Updated
Bedroom Ceiling
Vent Location

Keystone RV Company

SERVICE ADVISORY # 19-356

Cougar 32RDB Ceiling Vents

Fig. 1

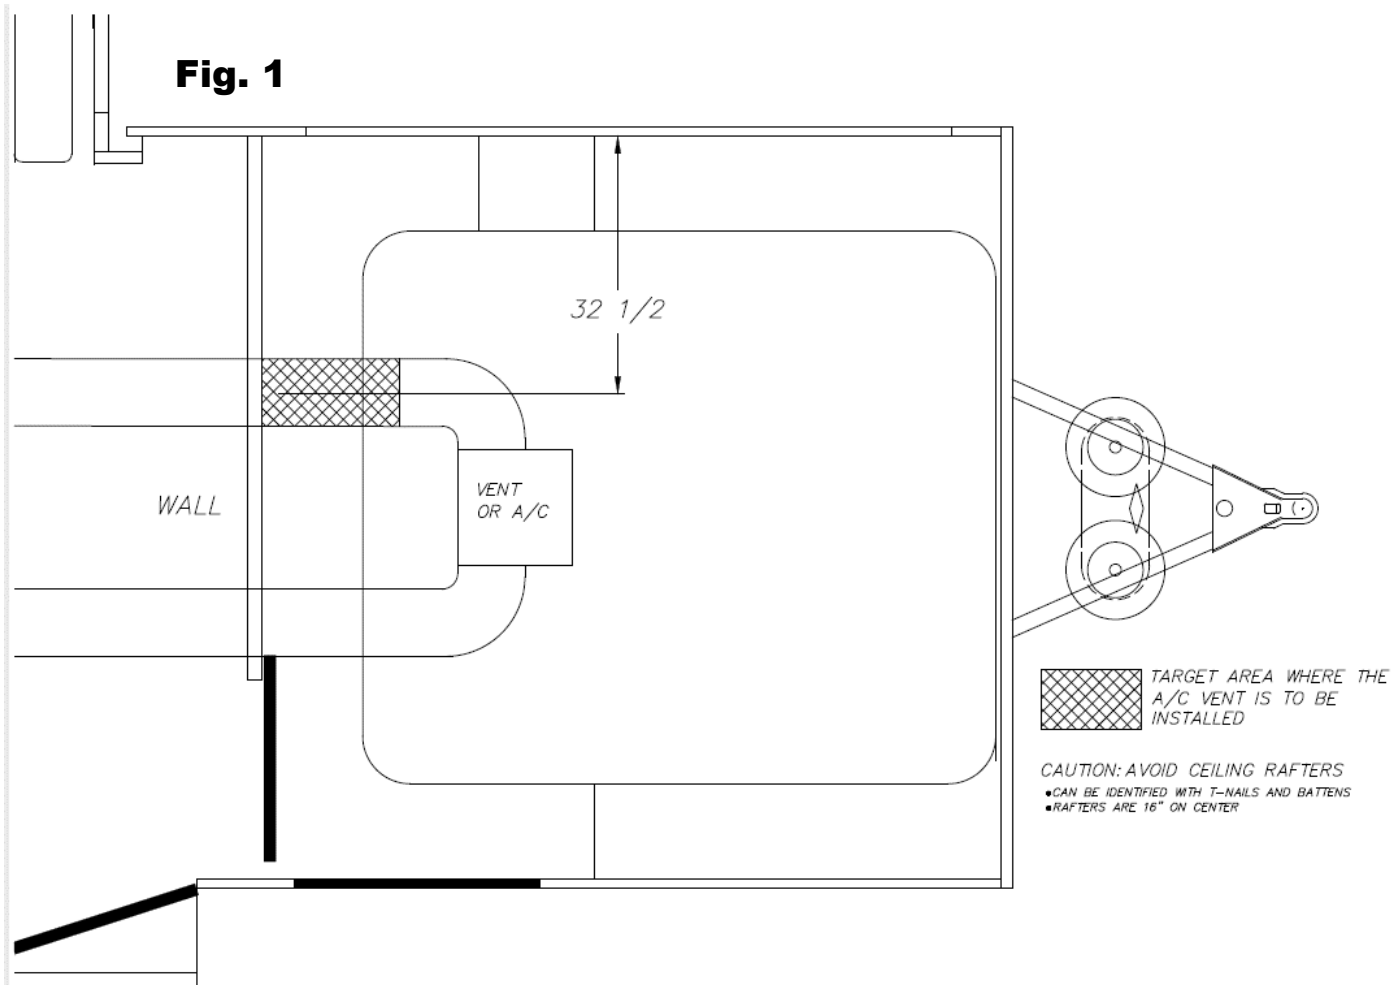
It has been determined that the Cougar 32RDB units may not have the adequate amount of A/C ceiling vents installed. The following procedure describes the locations and how to install the required A/C ceiling vents.

The bedroom A/C vent may or may not be installed, inspection is necessary. There should be a minimum of one A/C vent in the following rooms: bunk room, bathroom, main living area, and in the bedroom. If the ceiling vents are installed, proceed to warranty reimbursement for inspection.

In the bedroom an A/C vent can be installed between the rear wall of bedroom and within 15 inches of the 14" x 14" opening of the bedroom A/C or ceiling vent (2nd A/C is an option), Figure 1. The ceiling ducting, forward from the main A/C, runs parallel with the off-door-side wall. The center of this ducting is 32 ½" from the off-door-side wall. Do not drill into the ceiling rafters which are 16 inches on center (measurements can be taken from the ceiling batten trim). Using a 5" hole saw, add a vent as needed, drilling into ceiling panel and A/C duct, being careful to stop short before drilling into the top side of the A/C duct.

Install KRV#101886 Grill – 5" – Ducted Ceiling – AC in the bedroom using HVAC tape to seal the vents to the ducting.
